AGENDA

La Vergne Planning Commission
September 30, 2025 at 6:00 PM

Item #: 4. Site Plan – Restaurant and Retail Building at 192 & 198 Old Nashville Highway – Existing and Proposed Buildings of 15,521 Square Feet on 1.35 Acres. Requested by Huddleston Steele. Property located at 192 & 198 Old Nashville Highway (Tax Map 15M, Group E, Parcels 4 & 5). C-2 (Highway Service) Zoning District. Property owned by Better Home, LLC.

PROJECT NO. 1574-01	
SEPTEMBER DATE: 2025	DRAWN BY: HLP
	CHECKED BY: RWM
SCALE: 1"=30'	APPROVED BY: RWM
SHEET NO. C6.01

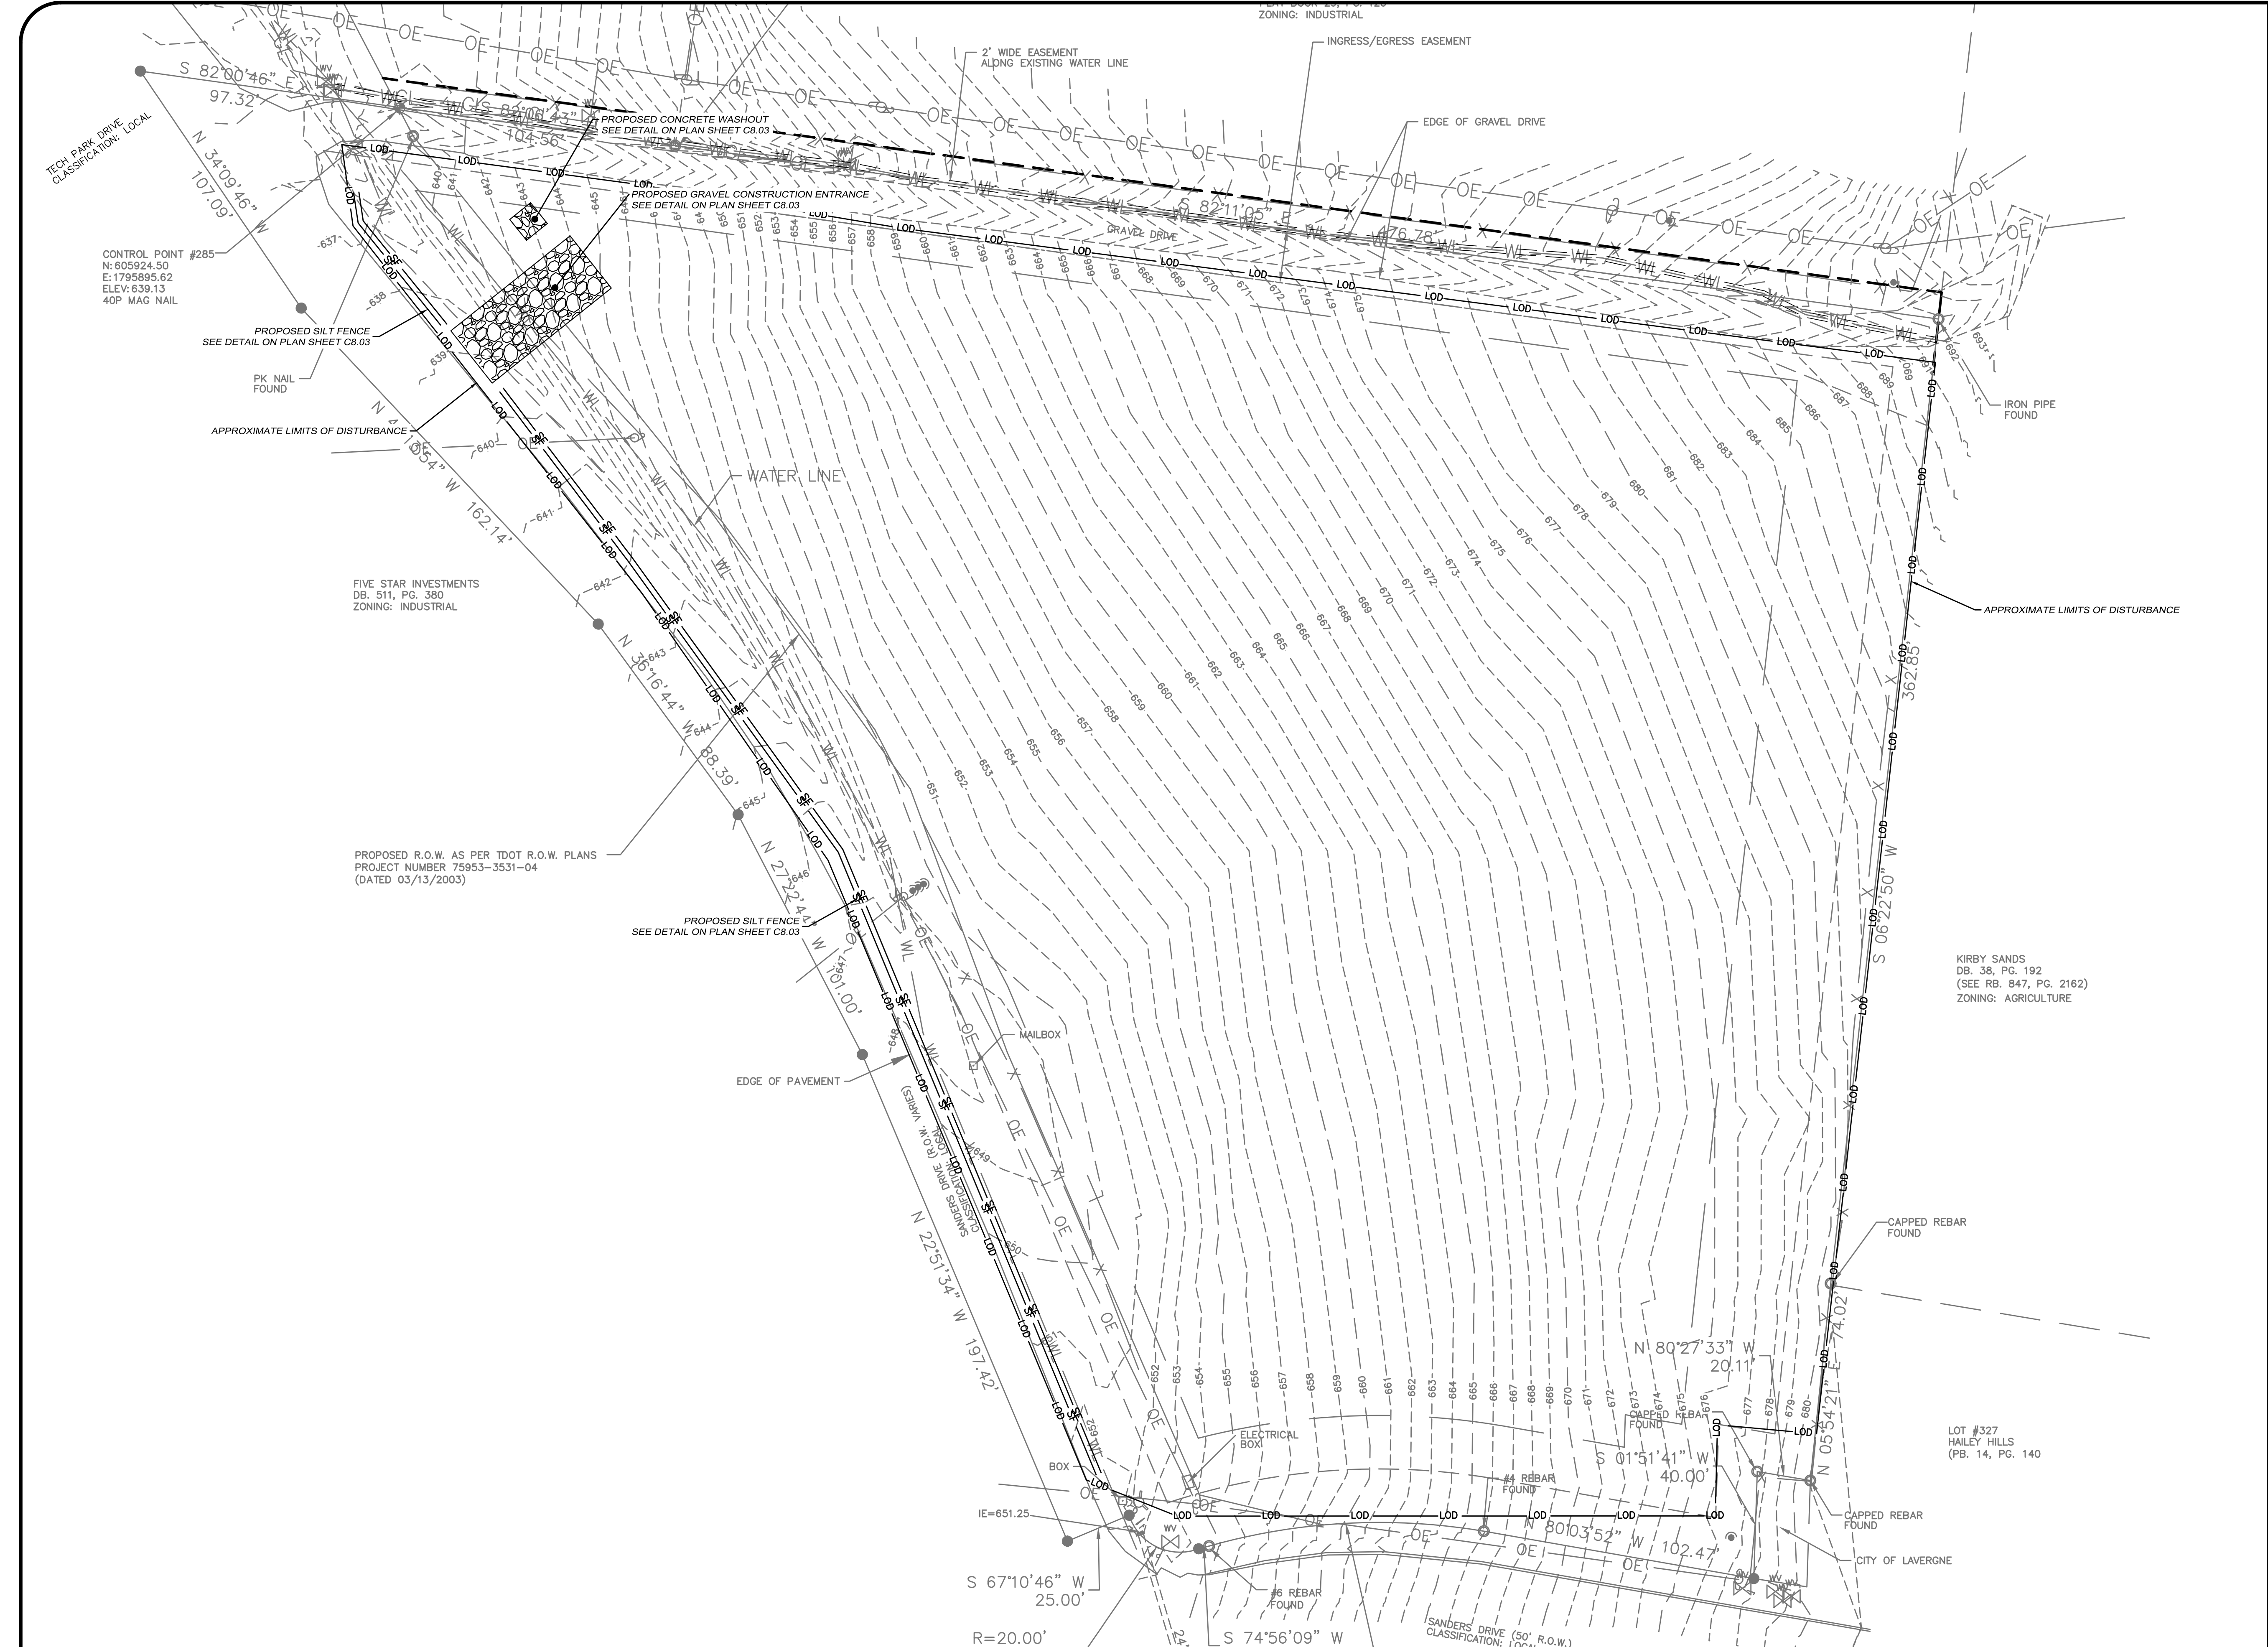
30. (Sheet C6.01, C6.02) Correct Silt Fence, Concrete Wash-out, and Construction Entrance references (the sheet reference is incorrect)
31. (Sheet C6.01) Show construction entrance graphically at 100 feet long.

34. (Sheet C6.01) Extend silt fence 100 feet in both directions
35. (Sheet C6.02) There is no Erosion Control Matting detail found on Sheet C6.04. Provide detail or change note.

39. (Sheet C6.02) This plan needs to show the grading necessary for the sediment ponds to comply with Item 38 above.
40. (Sheet C6.01) Show inlet protection at the existing culvert under the existing access drive along the north boundary.

PROJECT NO. 1574-01
SEPTEMBER
DATE: 2025
SCALE: 1"=30'
SHEET NO. C6.02

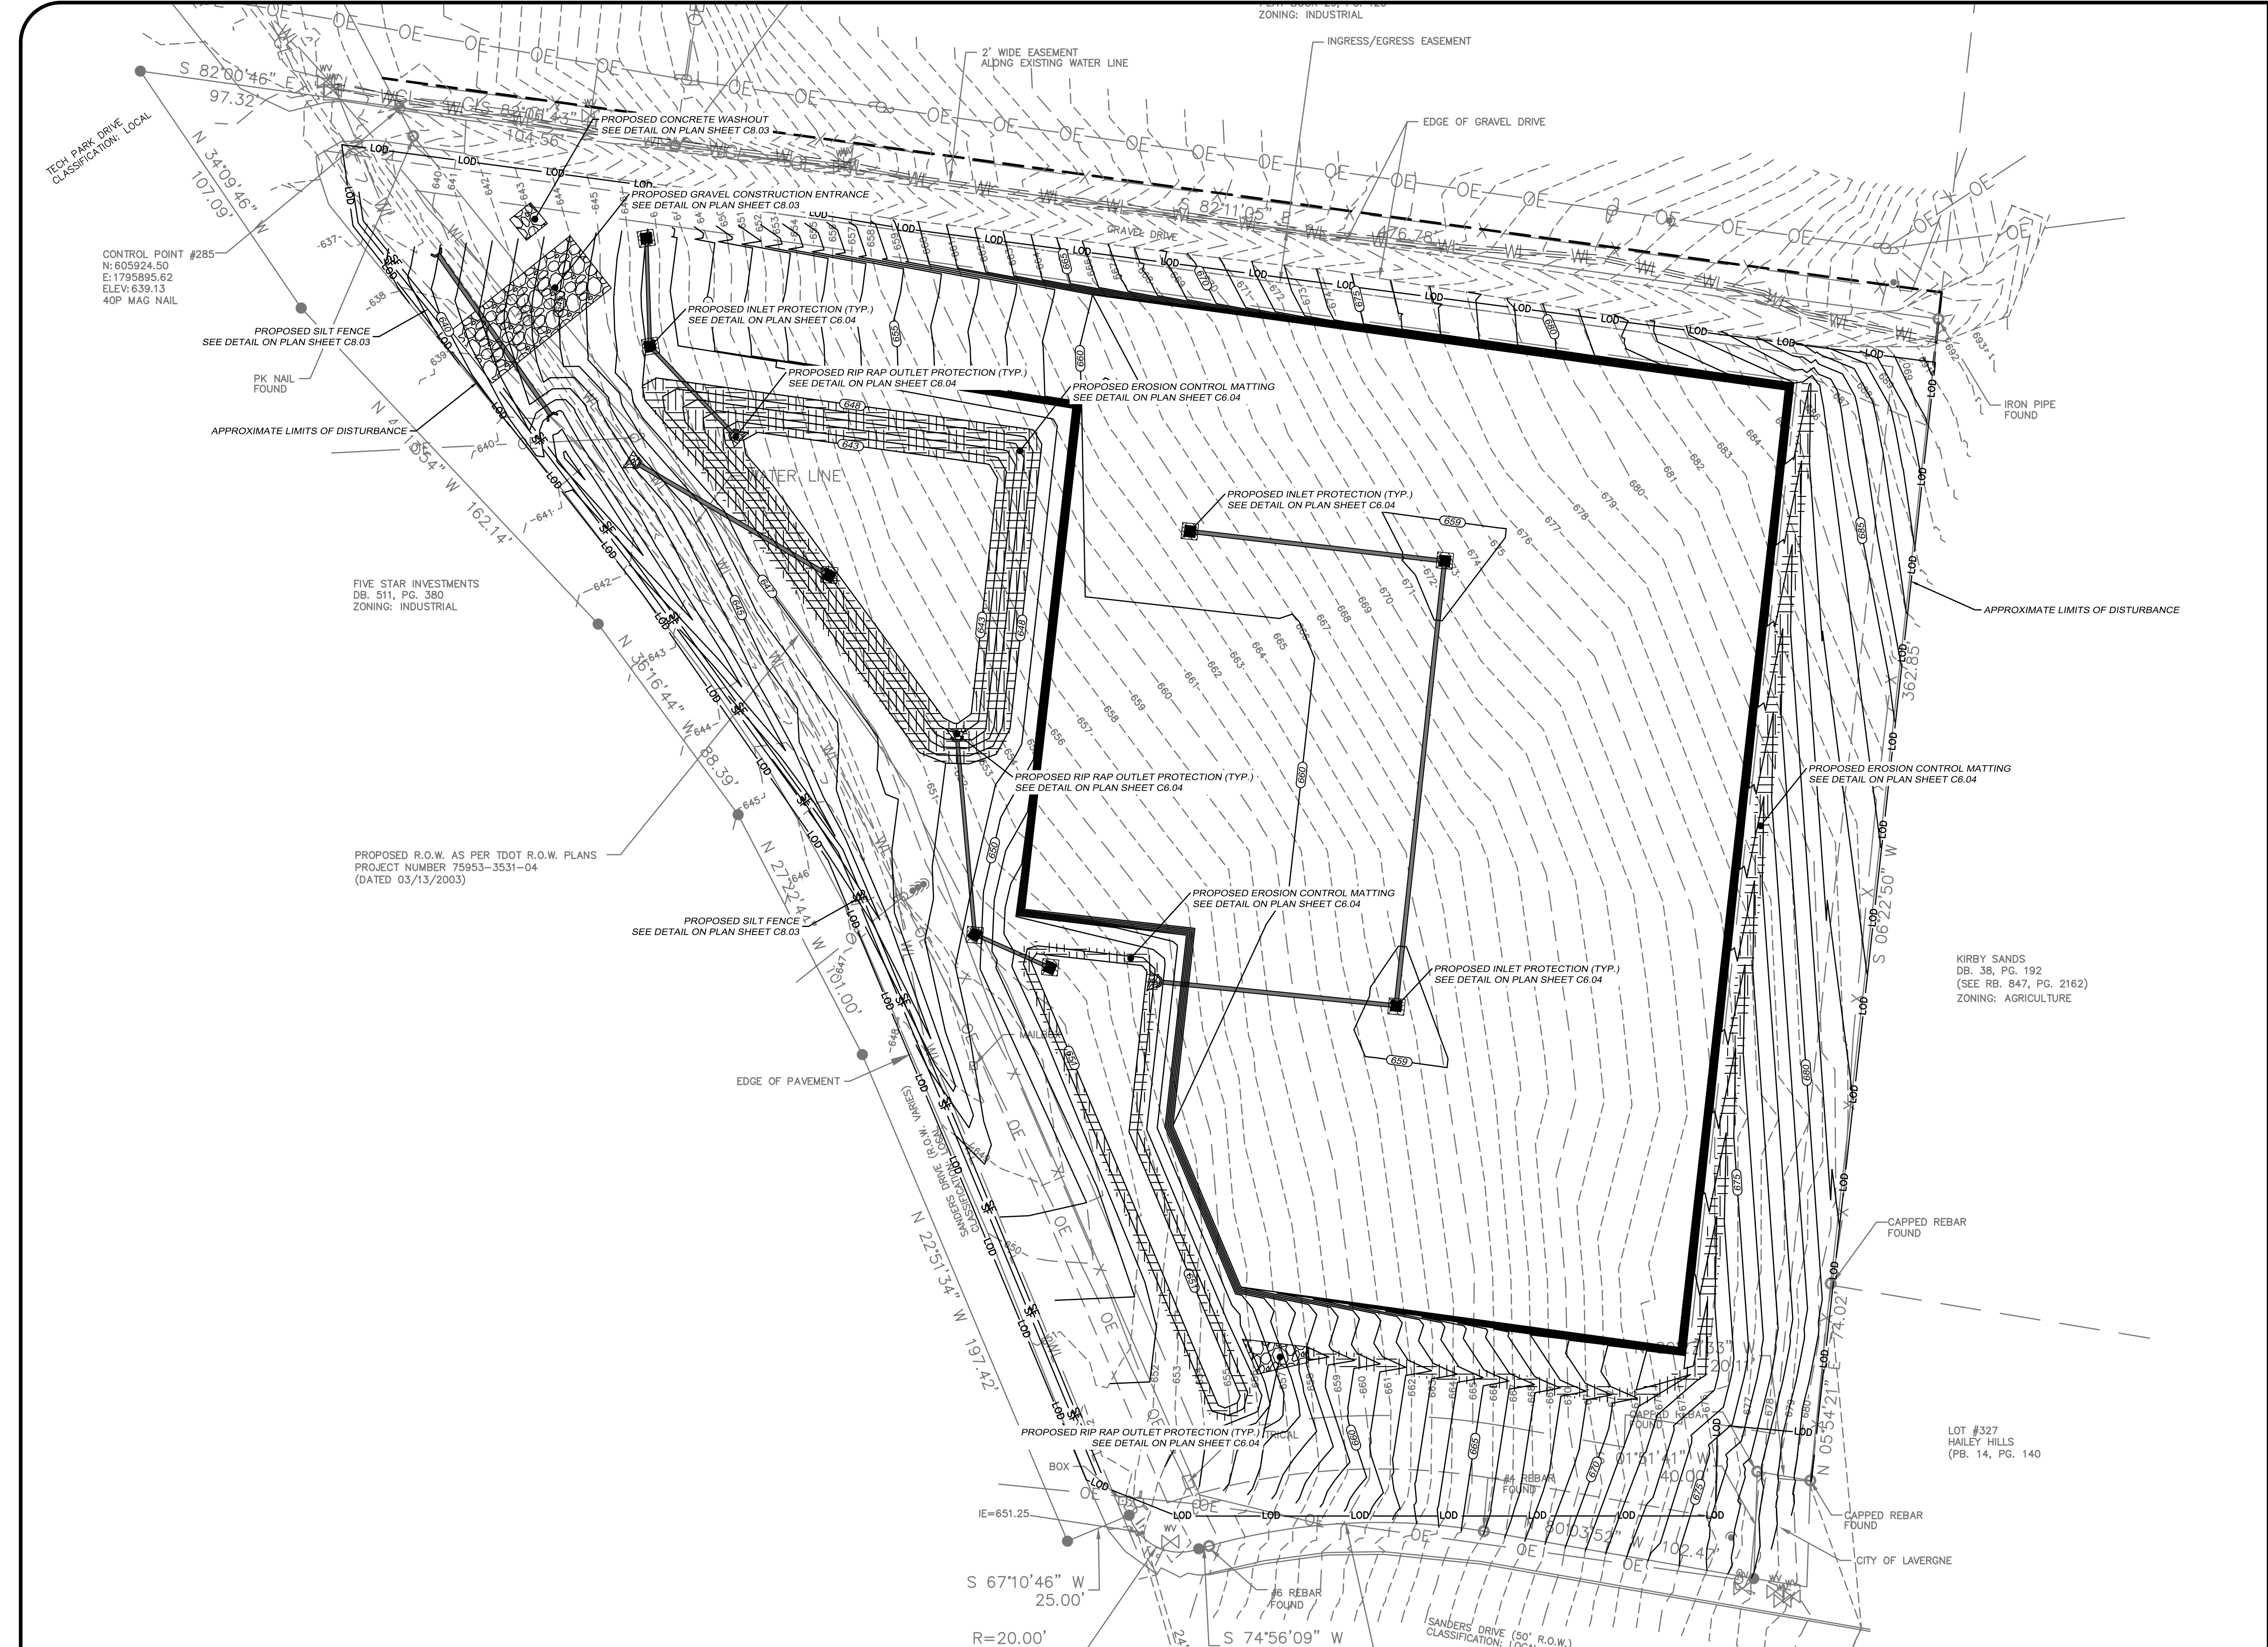
37. (Sheet C6.02) Notes are labeled as "Initial" notes. Change to "Intermediate" notes
38. (Sheet C6.02) Add a note that sediment ponds will be excavated and functional and run-off water diverted into them before topsoil stripping can begin on the main parking lot. It is understood that some grading will be required within the pad area to construct the sediment ponds.
